HERBATA DATA CENTRE, NAAS - RESPONSE TO REQUEST FOR FURTHER INFORMATION ("RESPONSE TO RFI") FROM KILDARE COUNTY COUNCIL

ADDENDUM TO CHAPTER 4 DESCRIPTION OF THE PROJECT AND
NEED FOR THE PROJECT

NI2615
01
June 2025

Figure 4.10: Locations of Mammal Passes in Palisade Security Fencing (extract of now submitted drawing BSM-ZZ-ZZ-DR-L-0311)

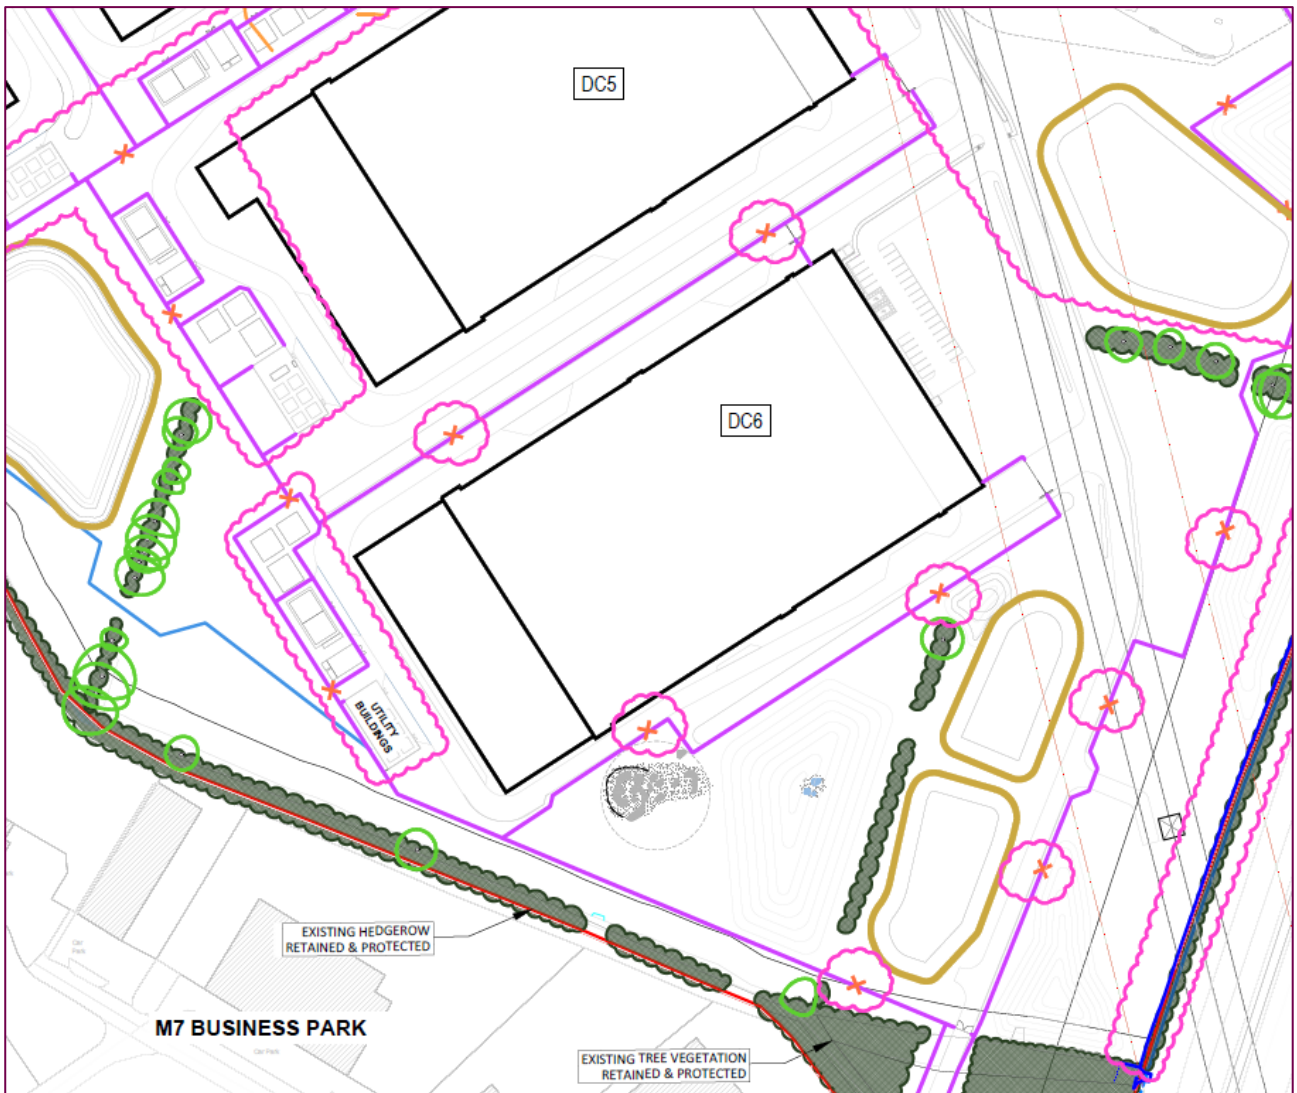
In consideration of the request for inclusion of a fencing arrangement *to allow for wildlife access and passage through the site*, an amendment has been made to the proposed Landscape Masterplan to include mammal passes in fences throughout the full extent of the site. The number, location and dimensions of the mammal passes was established following engagement between the project ecology and landscape team. The inclusion of the mammal passes has not required changes to the submitted landscape planting proposals.

Figure 4.10 below (extract of drawing number BSM-ZZ-ZZ-DR-L-0311 Landscape Boundary Treatments Plan) illustrates the location of the mammal passes; Figure 4.11 below (extract of drawing number 22217-RKD-ZZ-ZZ-DR-A-1400 Proposed Boundary and Fence Details) illustrates the detailed dimensions of the fencing.

Figure 4.11: Mammal Pass in Palisade Security Fencing (extract of now submitted drawing 22217-RKD-ZZ-ZZ-DR-A-1400-PROPOSED BOUNDARY AND FENCE DETAILS)

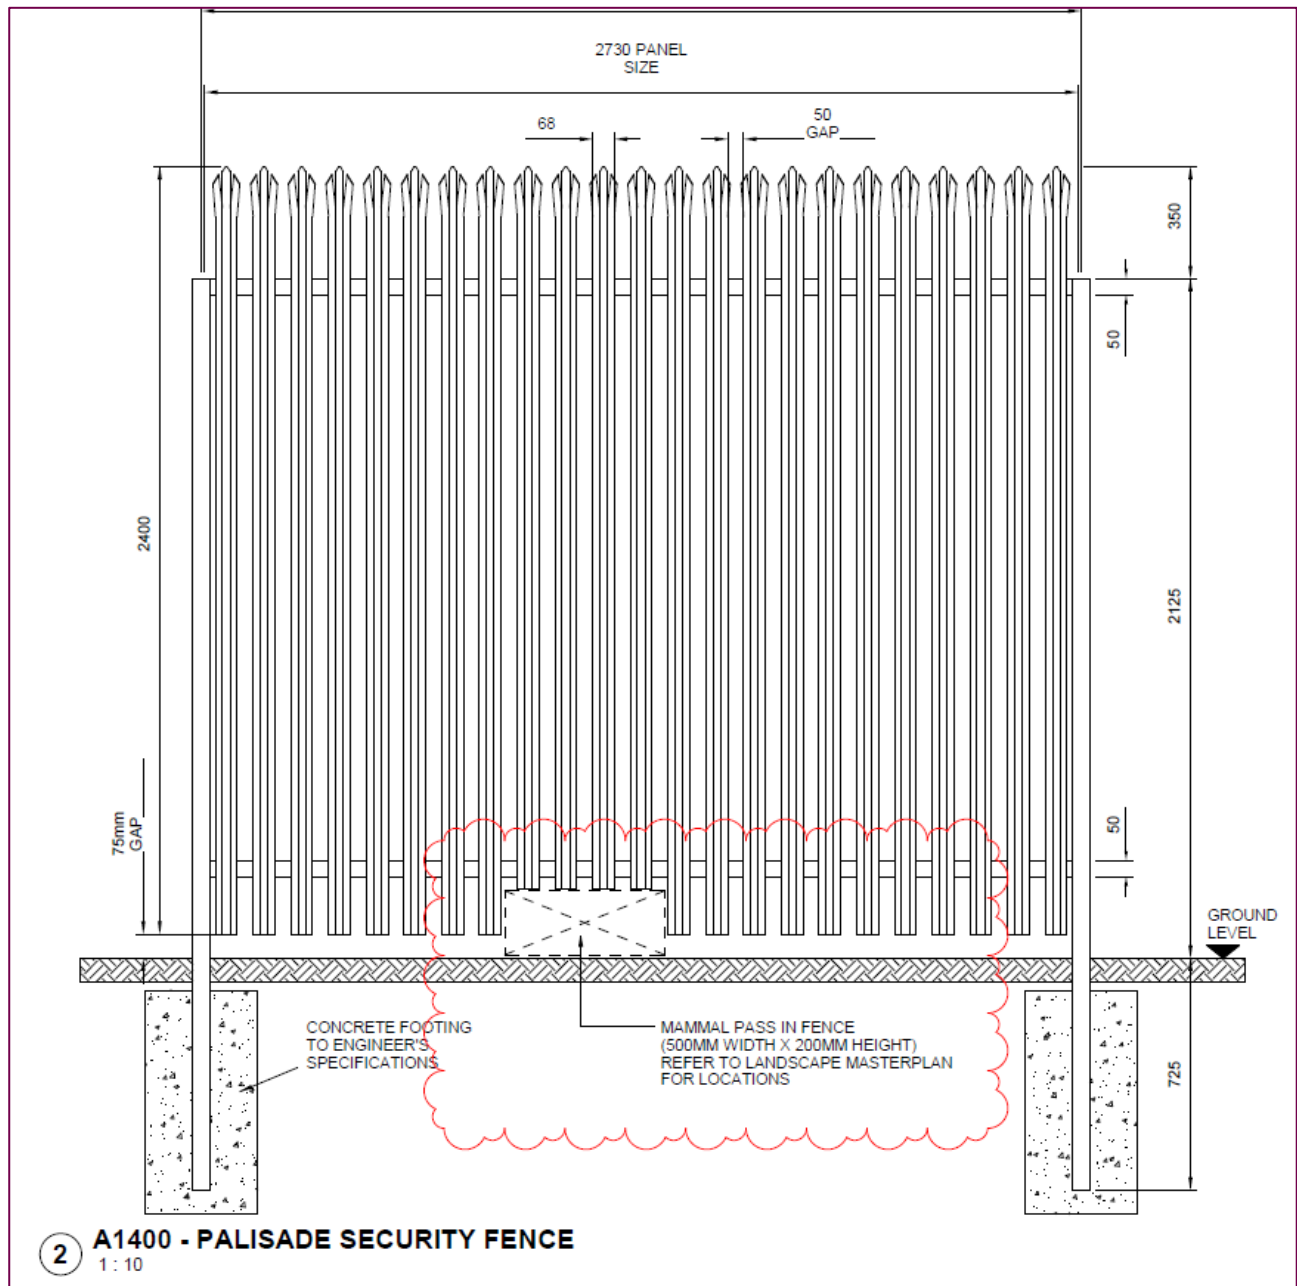
Mammal passes are proposed at locations throughout the site including all *perimeter* fences and *internal* fences within the site (for example around each Data Centre building). A gap at the foot of the proposed fencing, of 500mm (width) x 200mm is determined sufficient for all potential mammal species and should ensure access and passage throughout the site. There are no proposed amendments to the overall height, materials or layout of the proposed fencing.

Figure 4.13: Amended Construction Phase Layout (extract from now submitted Updated CTMP, Volume II, Appendix 4.6)

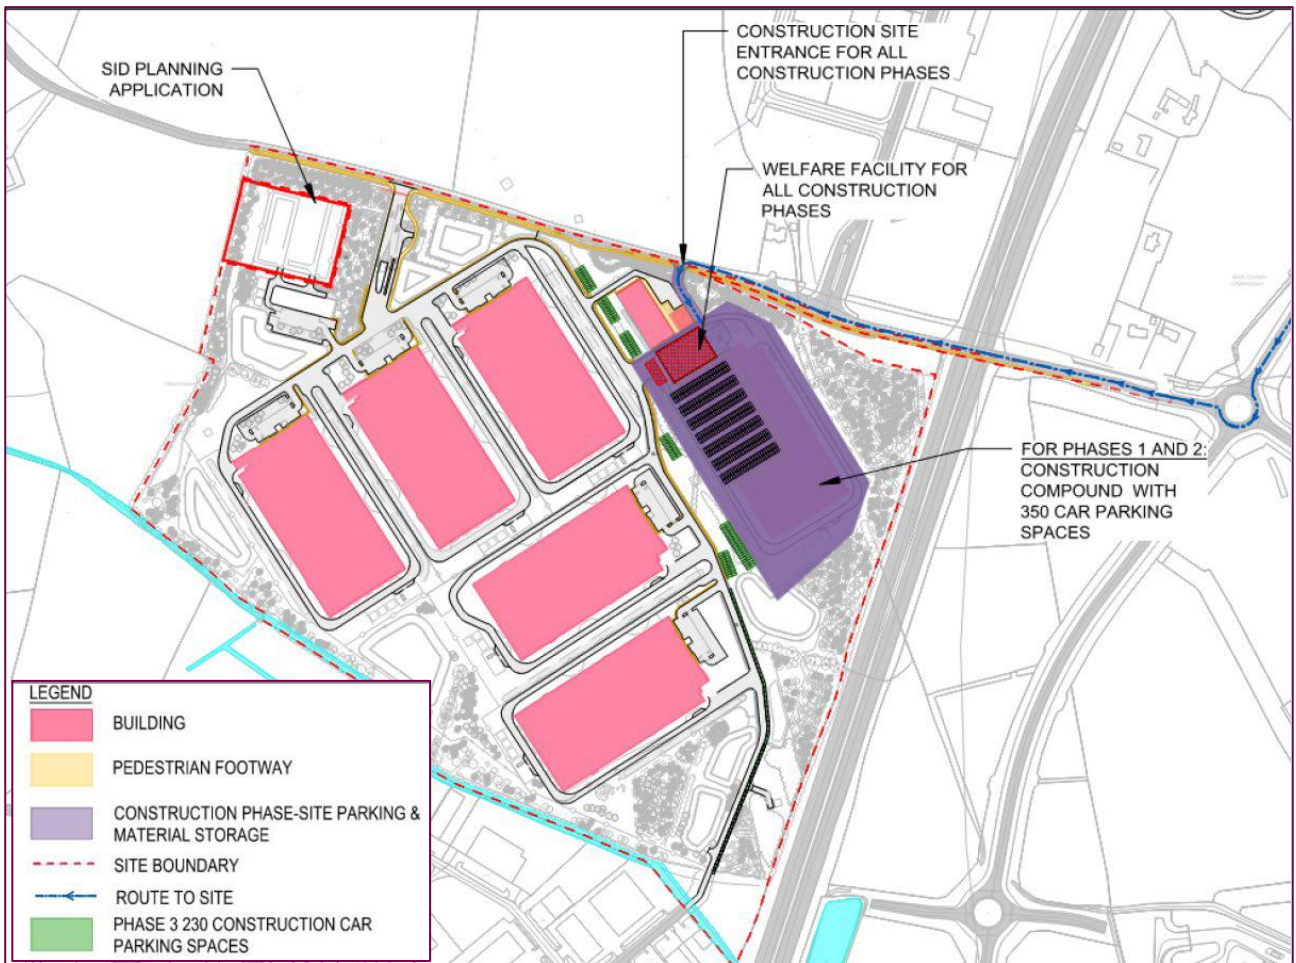
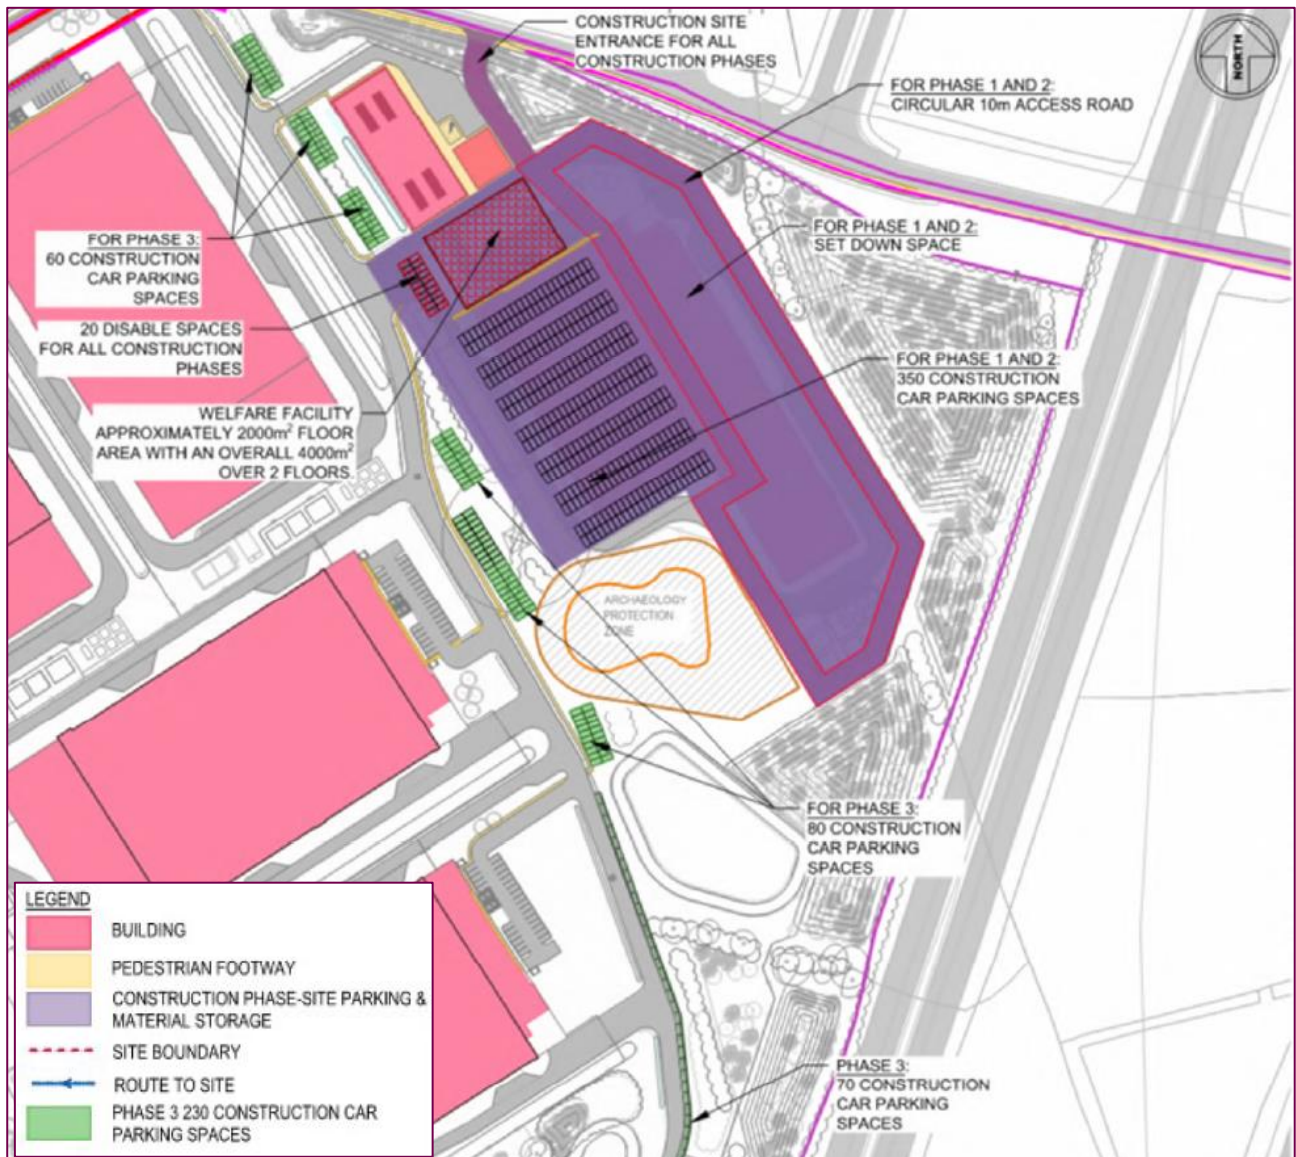
Whilst the proposed site phasing remains consistent with that set out within the submitted EIAR, the amended design for Data Centre 4 has necessitated an amendment to the construction compound (parking and material storage) in the vicinity of Data Centre 4.

For the purpose of comparison, Figures 4.12 and 4.13 below, illustrate the previously submitted layout detail for Data Centre 4 and (amended) proposed layout detail for Data Centre 4 respectively as set out in the now submitted Updated CTMP (Volume II, Appendix 4.6).
